ADDENDUM NO.: 738

Description: Furnish, Deliver and Install
Signage

Project: John Jay College – Haaren Hall

Specifics of the Addendum: Extend Bid Opening Date and Provide Responses to Requests for Information.

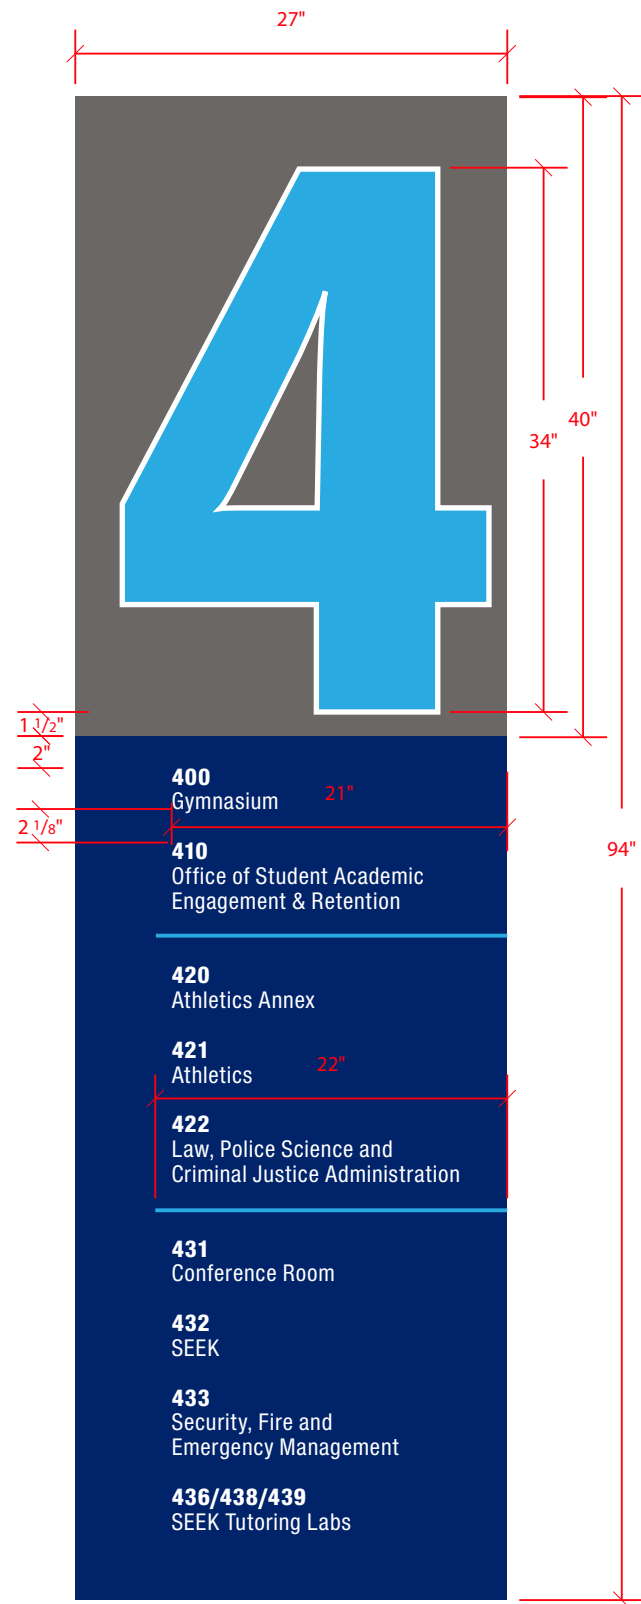
6Q: Doc 1a IFB...General Specification for signage. Last paragraph...please confirm that these prototypes are to be produced ONLY after award of the project.

6A: *Confirmed. The entity who is determined to be the low quote will be asked to provide the prototypes as part of the submittal and review process.*

1 SIGN TYPE C3 - FLOOR DIRECTORY
SCALE: 1" = 1'-0"

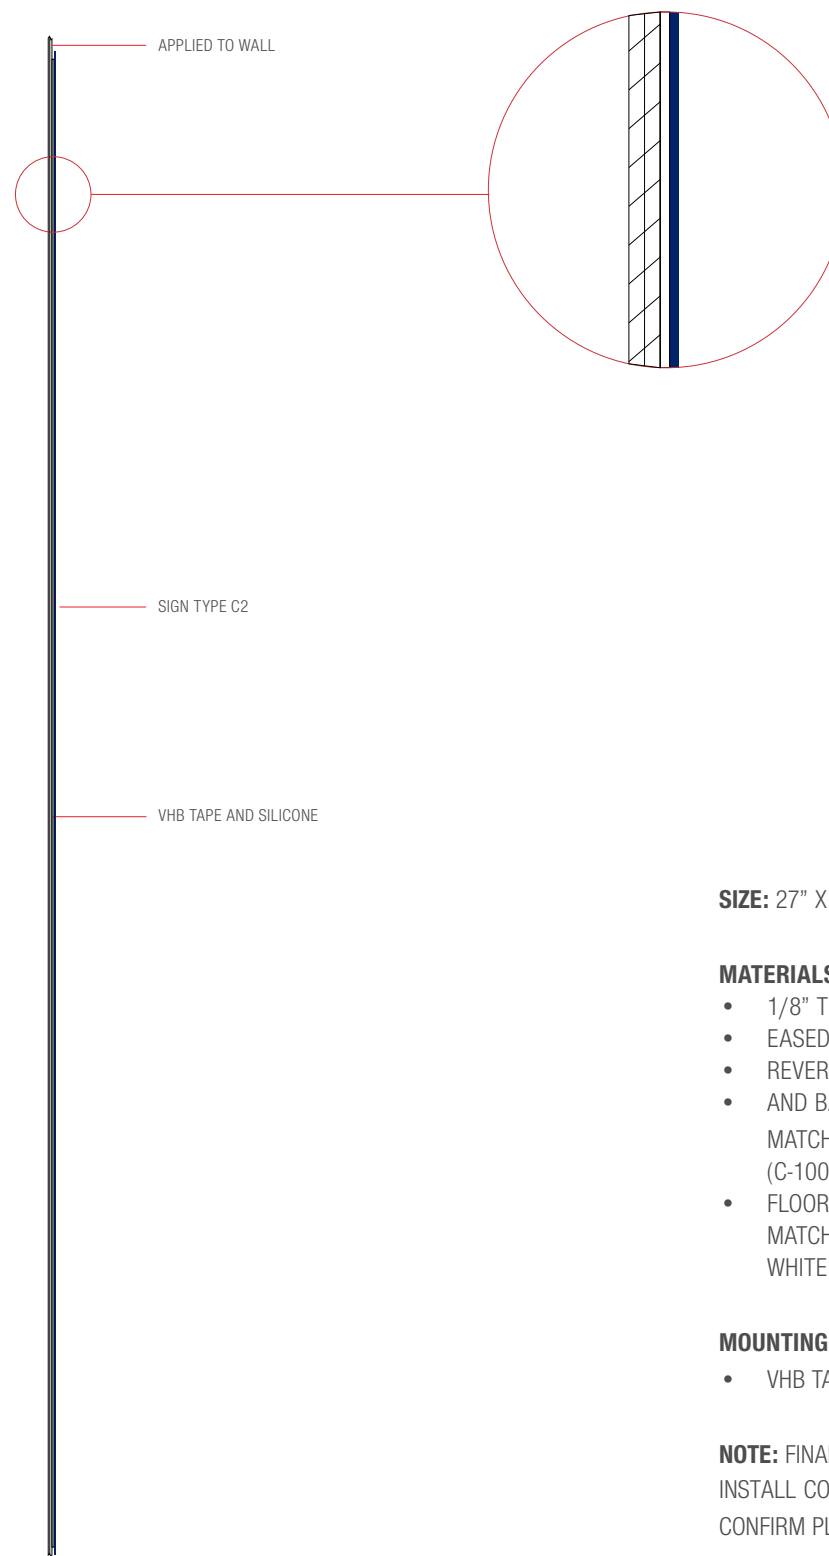
7Q: Can you re-post pages 47, 69 & 70 for sign type C3 floor directory...they are very blurry & pixelated. Details cannot be read.

7A: *Attached are legible copies of the requested pages.*
